LIGO-T0900334-v2

ADVANCED LIGO

Response to:
Stray Light Control PDD Comments

This document responds to the questions posed by the SLC PDR committee.

Figure 15: Cylindrical Wide Angle Baffle, H1 ITMX

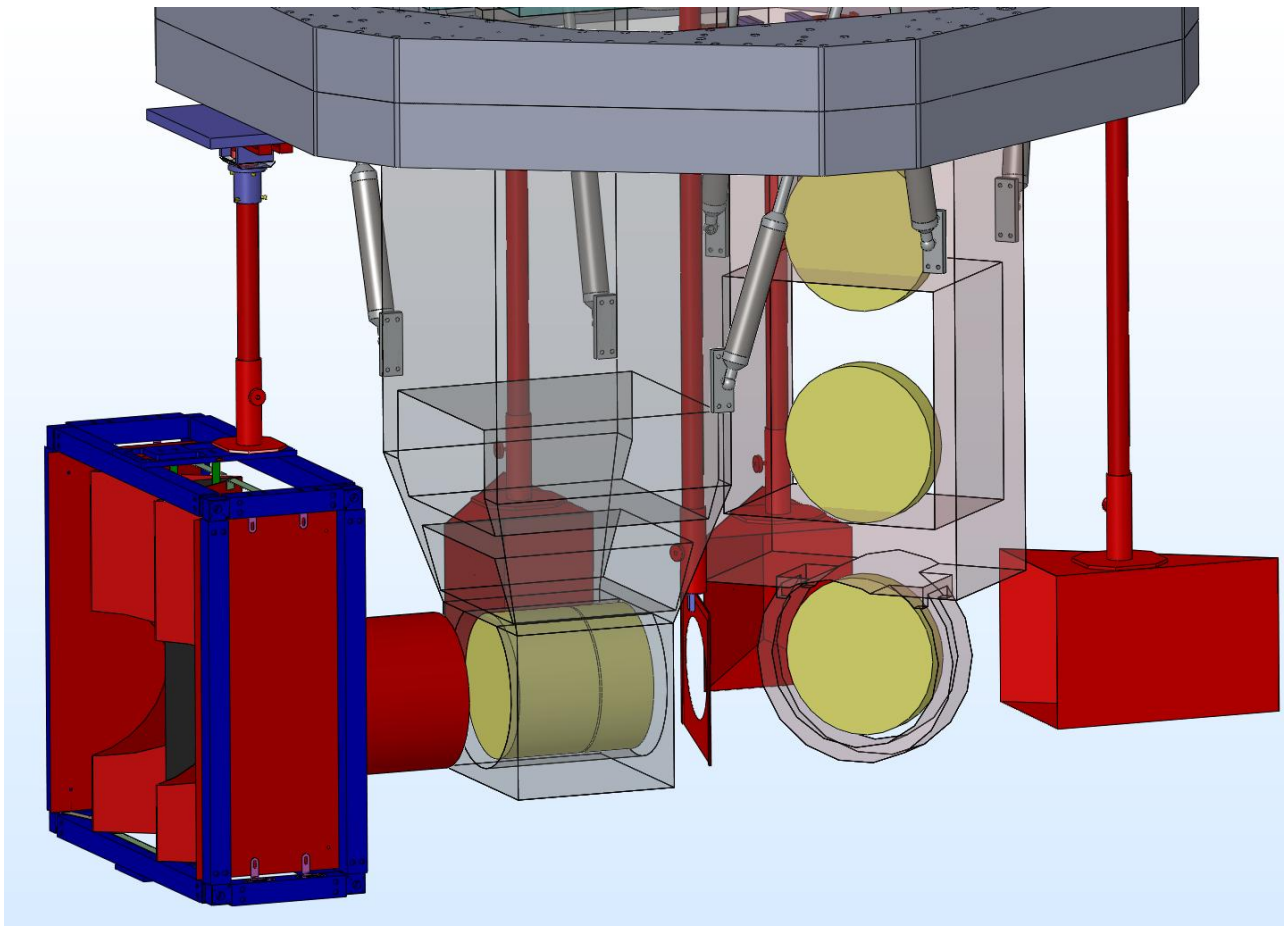
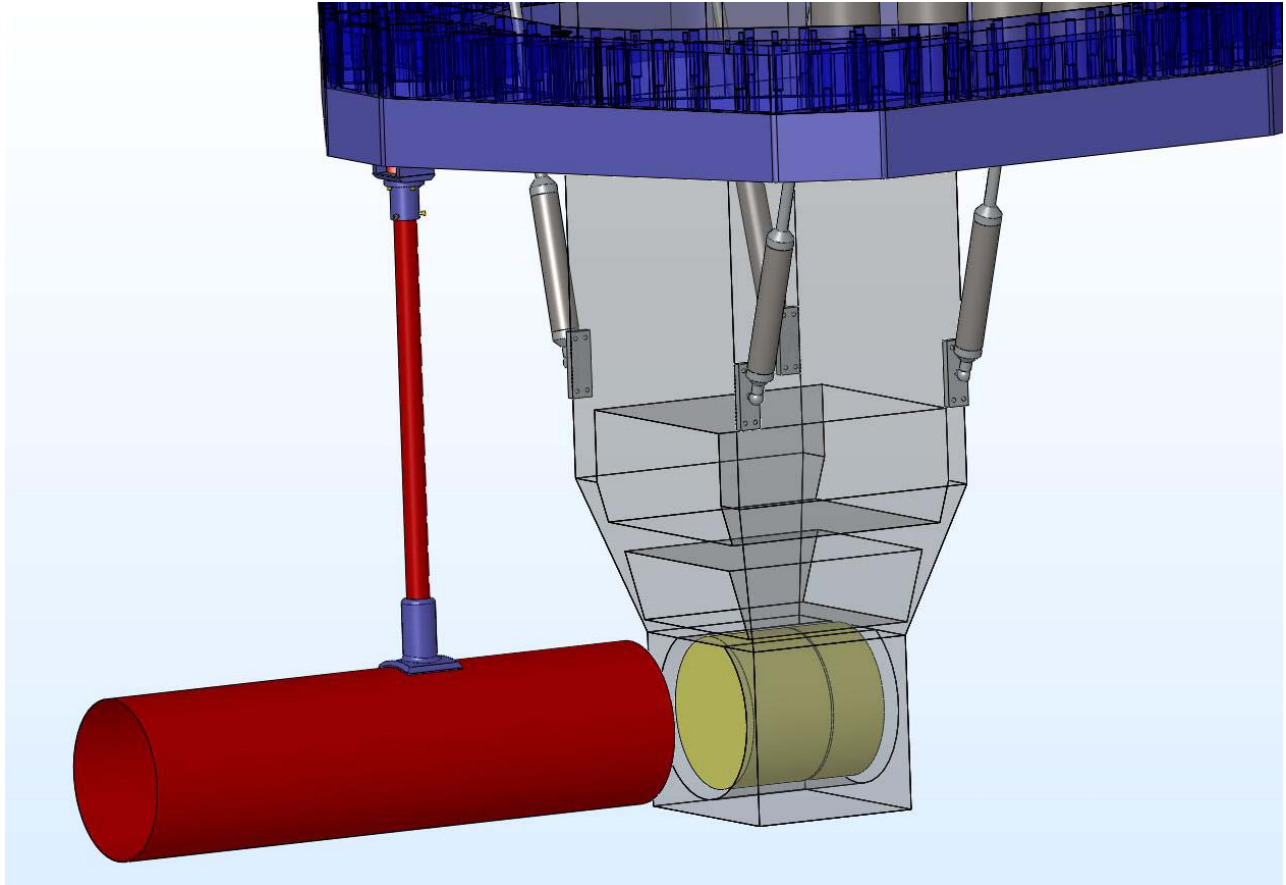
2.6.3.1 Round arm cavity baffle vs square?

A cylindrical Wide Angle Baffle is shown behind the louver Arm Cavity Baffle and in front of the ITM HR side of H2 in BSC7 in Figure 15.

Similarly in Figure 16, a cylindrical Wide Angle Baffle is shown in front of the ITM HR side of H1 in BSC3.

Figure 17: ZEMAX Layout of H1 and H2 ITM Wide Angle Scatter Baffles, With Camera View of the HR Surfaces

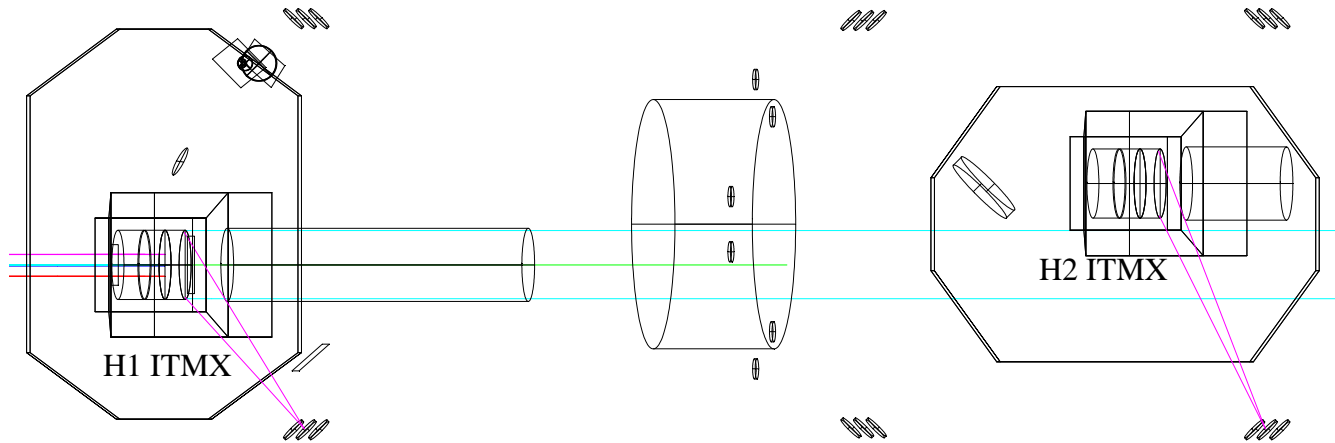
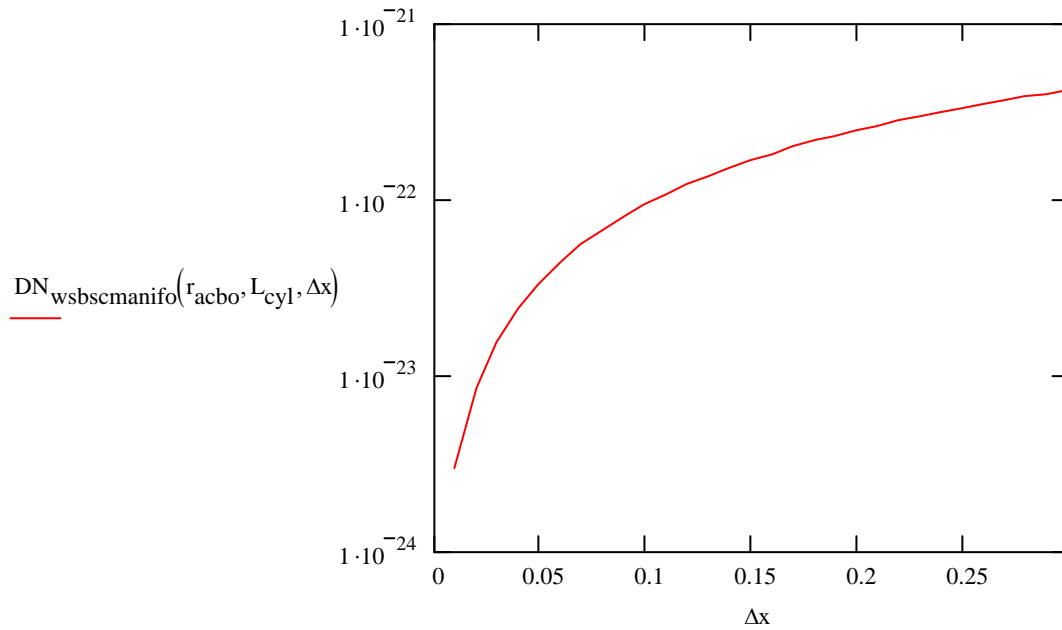
2.6.3.4 Wide angle camera view from a viewport?

The HR surfaces of the ITM in H1 and H2 can be viewed at a wide angle from the viewports in the BSC chamber, as shown in Figure 17. To enable this, the H1 cylindrical baffle is placed 210 mm from the ITM HR surface, and the H2 cylindrical baffle is placed 130 mm from the ITM HR surfaces.

The wide angle scattered displacement noise from the BSC, increases with the gap between the ITM HR and the cylindrical baffle, as shown in Figure 18. At the widest gap of 210 mm, the wide angle scattered light from the BSC chamber is still below the AOS requirement, as seen in Figure 22

Figure 21: Cryopump Baffle and Manifold Baffle SUS transfer function

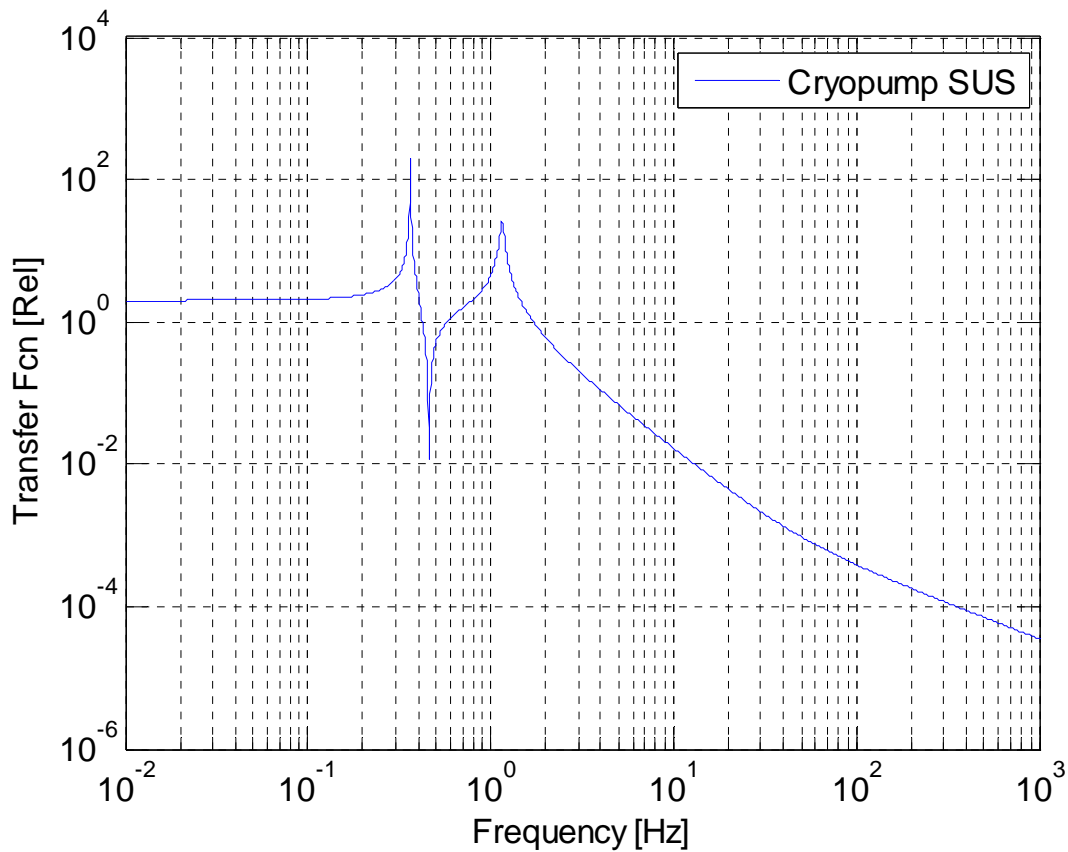
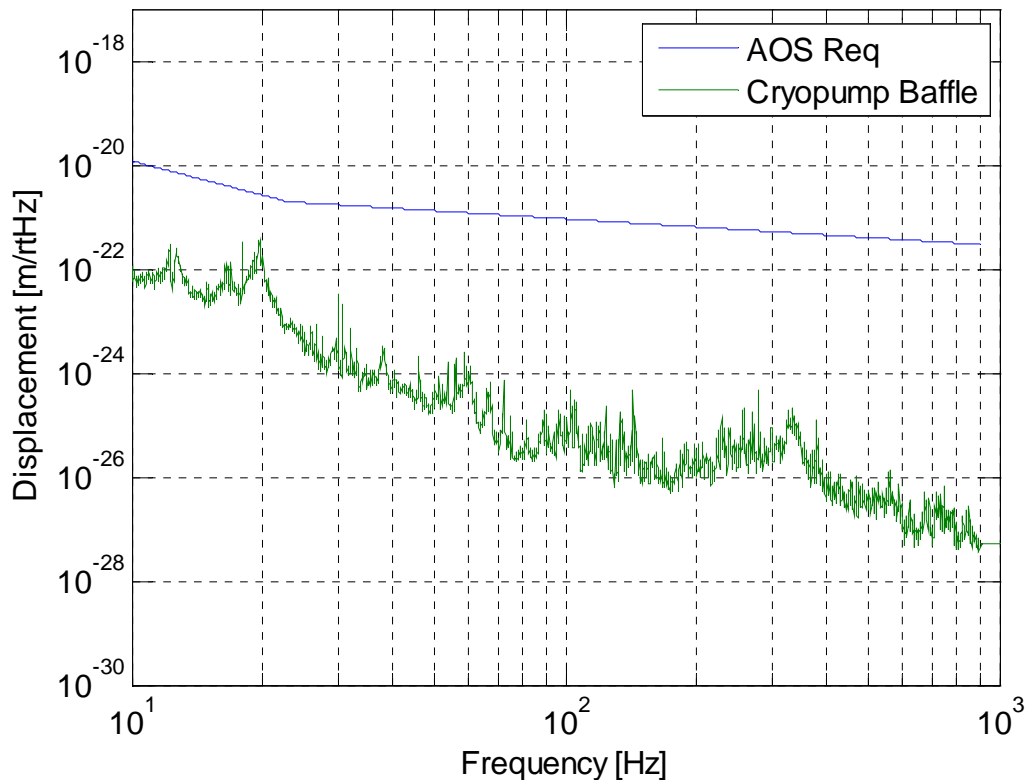
2.7.3 Suspension Transfer function

How much margin is available for less than ideal transfer function? The Cryopump Baffle scatter has many orders of magnitude margin.

Figure 22: COC Wide Angle Scattered light from 1) BSC chamber, 2) Manifold Wall, and 3) Manifold Baffle

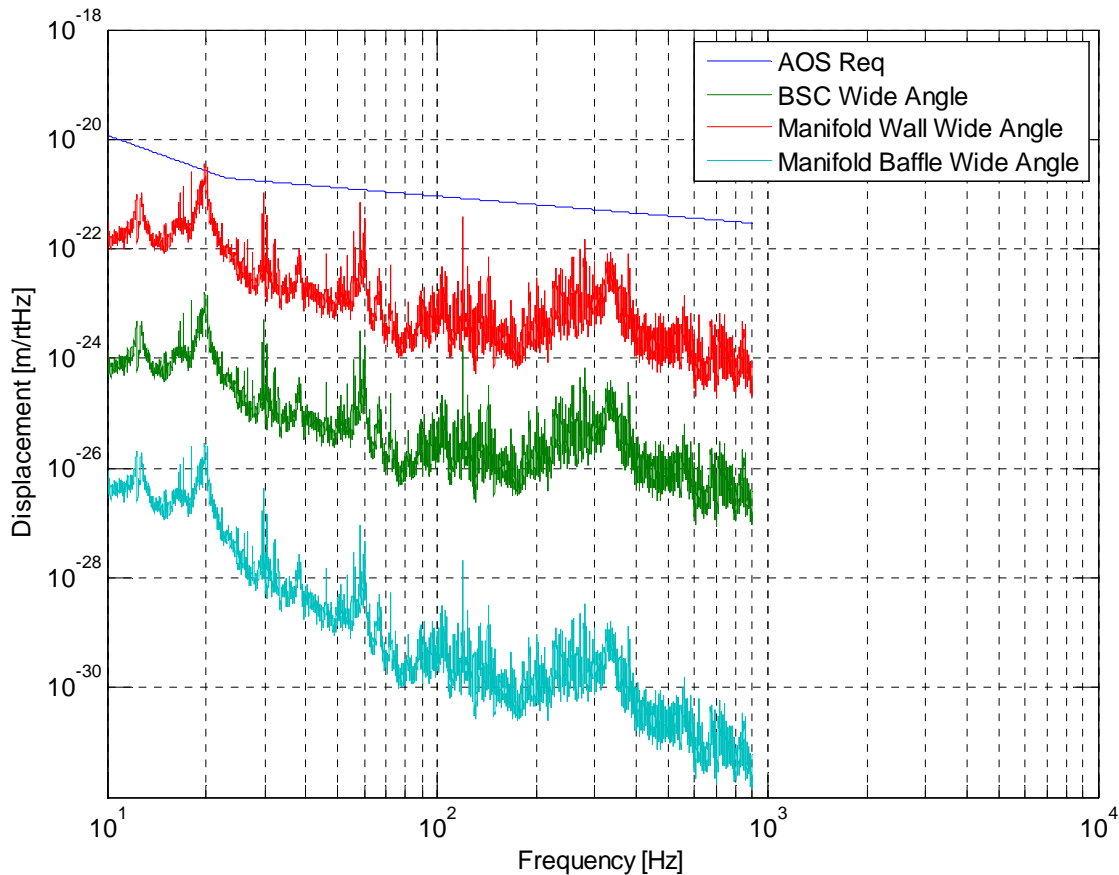
2.7.4 Displacement Noise from Manifold Baffle

The surfaces of the ITM and ETM scatter wide-angle light into four paths: 1) most of that scattered light is captured by the wide-angle baffle that hangs directly in front of the HR surface of the COC; 2) some of the light is scattered at angles close to 90 deg from the normal to the COC surface and will hit the walls of the BSC chamber and re-scatter from the COC into the IFO mode; 3) some of the light will pass through the holes in the arm cavity baffle and will hit the manifold wall and re-scatter from the COC into the IFO mode; and 4) some will hit the suspended manifold baffle and re-scatter—the manifold baffle hides the corner of the manifold/viewport flange and avoids the retro-reflection.

The scattered light displacement noise from sources 2, 3, and 4 is shown in Figure 22.

Figure 23: PRM ELLIPTICAL BAFFLE

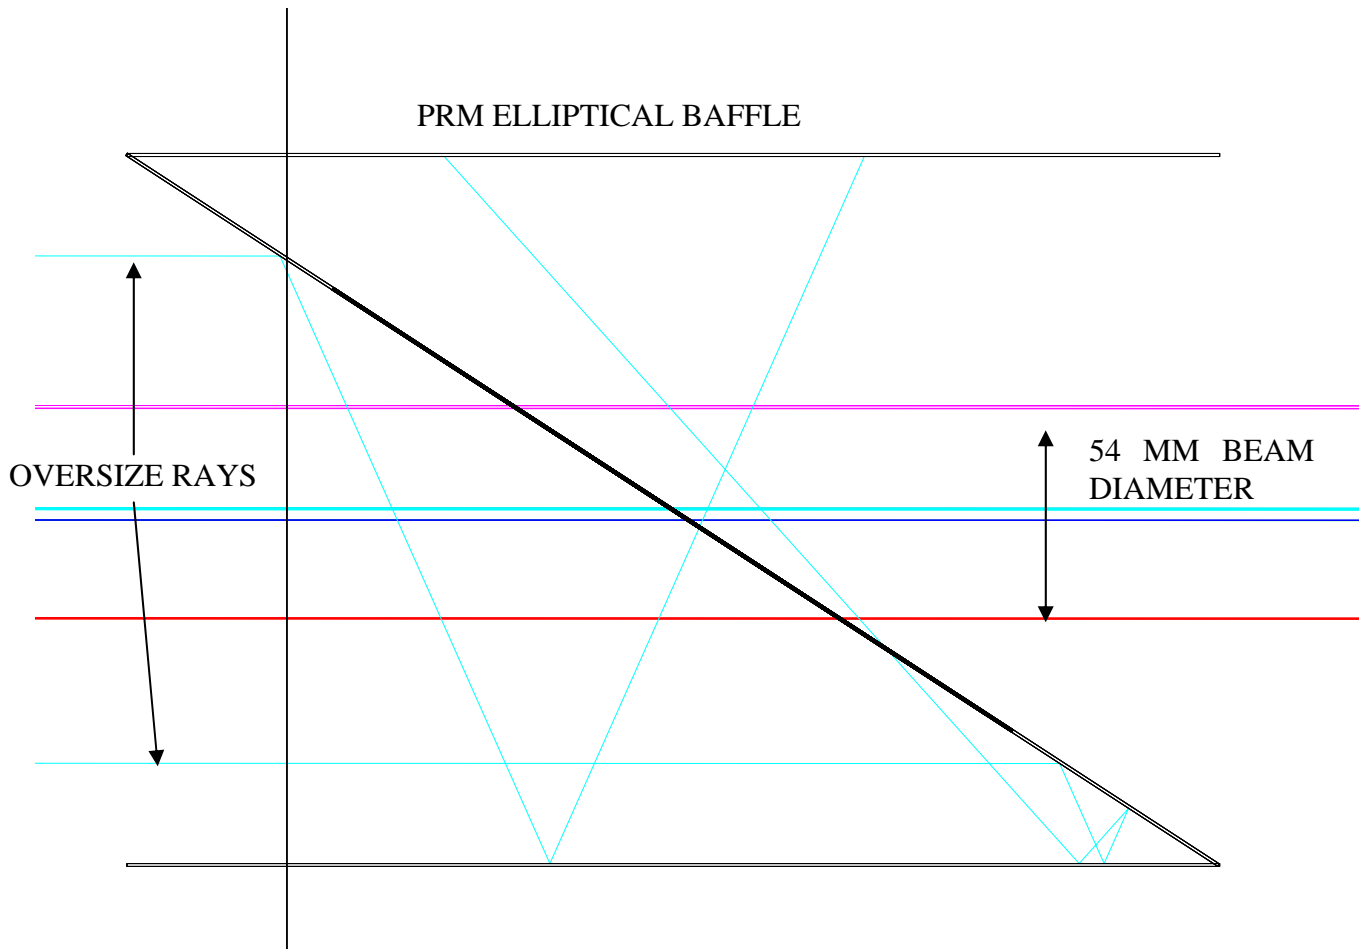
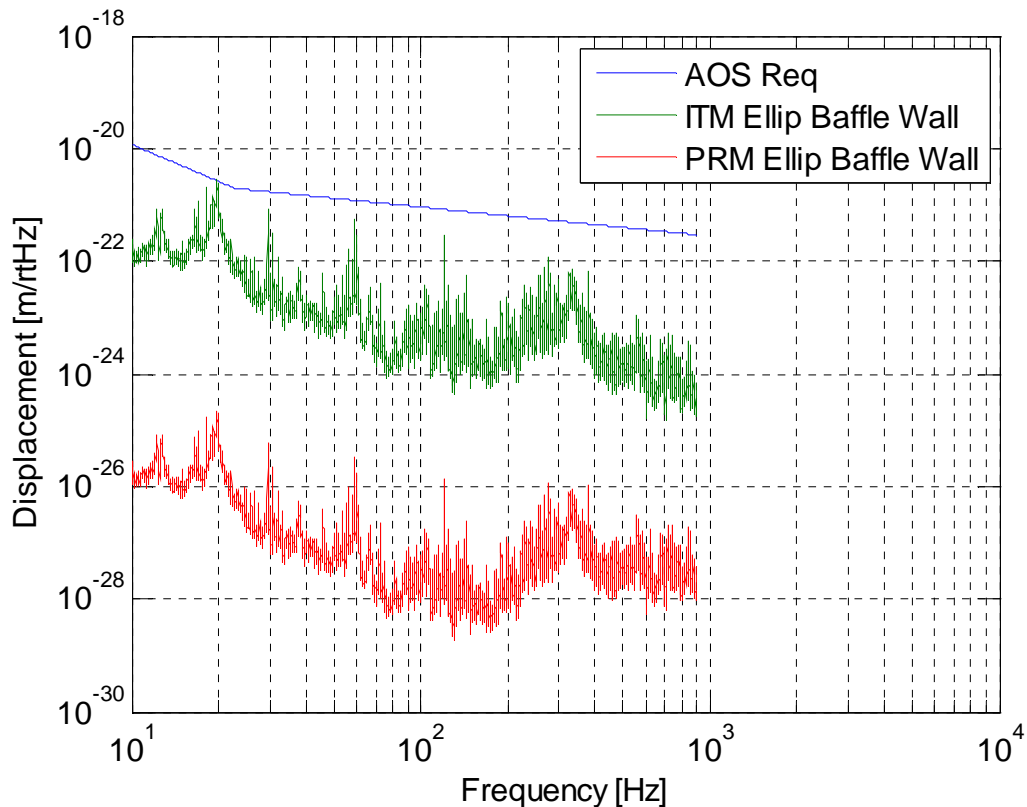
2.8.1 PRM Elliptical Baffle

A further function of the PRM Elliptical baffle is to keep the oversize Gaussian beam in the power recycling cavity beam from hitting the structure of the BS suspension, as shown in Figure 23.

The scattered light displacement noise that would occur, if the PRM Elliptical baffle were not present and the Gaussian beam from the PR3 would hit the suspension structure of the BS and eventually scatter from the chamber walls, is shown in Figure 25. The noise is four orders of magnitude lower than the requirement; therefore, the PRM Elliptical Baffle will be eliminated.

Figure 24: ITM Elliptical Baffle

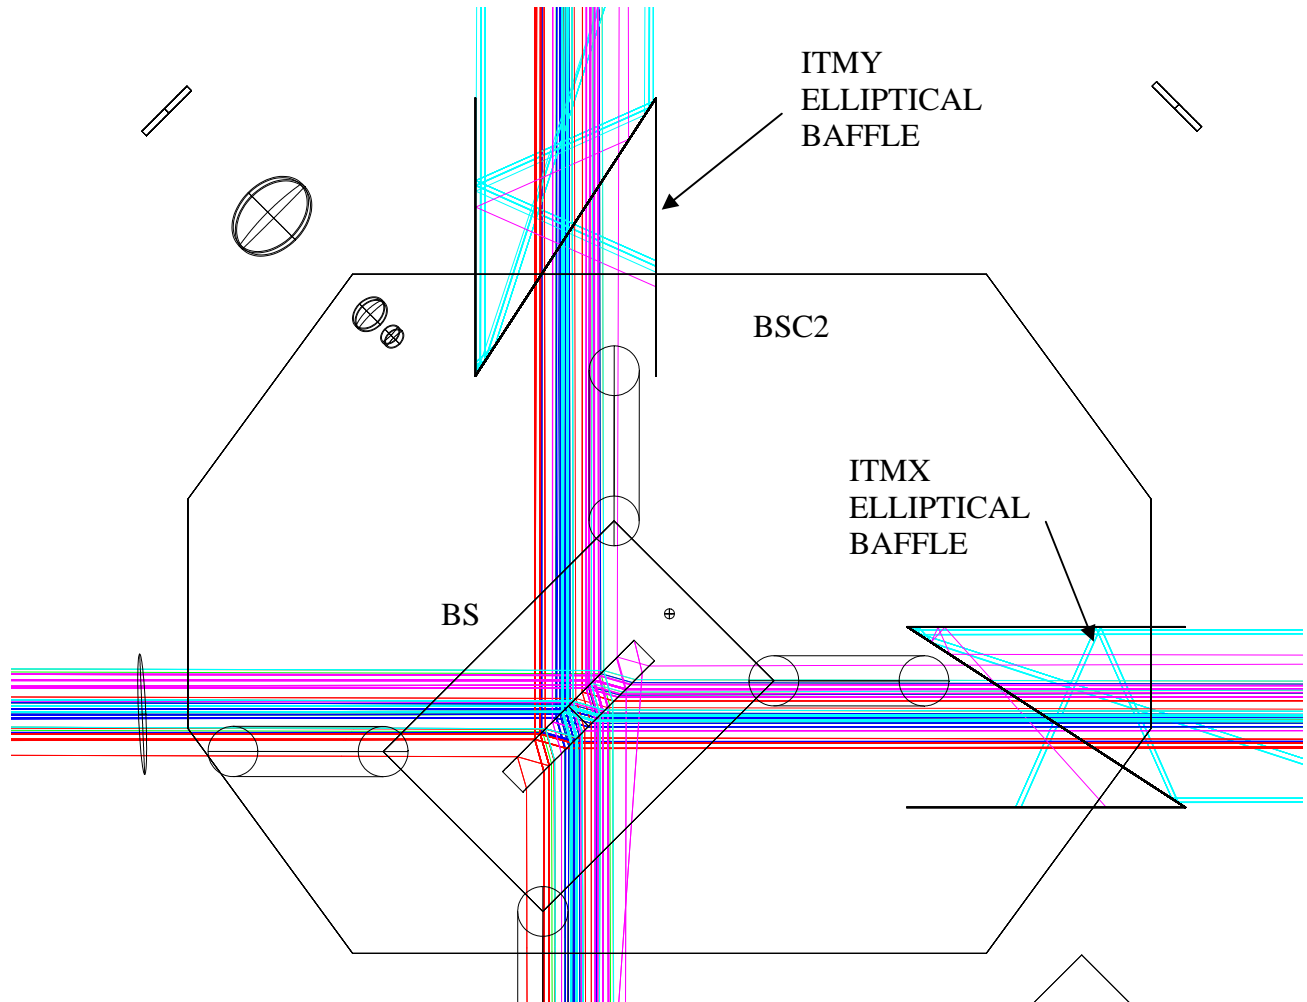
2.8.2 ITM Elliptical Baffle

The ITM Elliptical baffles serve the same function in keeping the oversize Gaussian beams from the arm cavity from hitting the structure of the BS suspension.

Additionally, the ITM Elliptical baffles function as beam dumps to catch the ITM and CP ghost beams, as shown in Figure 24.

The scattered light displacement noise that would occur, if the ITM Elliptical baffle were not present and the Gaussian beam from the arm cavity would hit the suspension structure of the BS

and eventually scatter from the chamber walls, is shown in Figure 25. Therefore, the ITM Elliptical baffle is needed to control the scattered light.
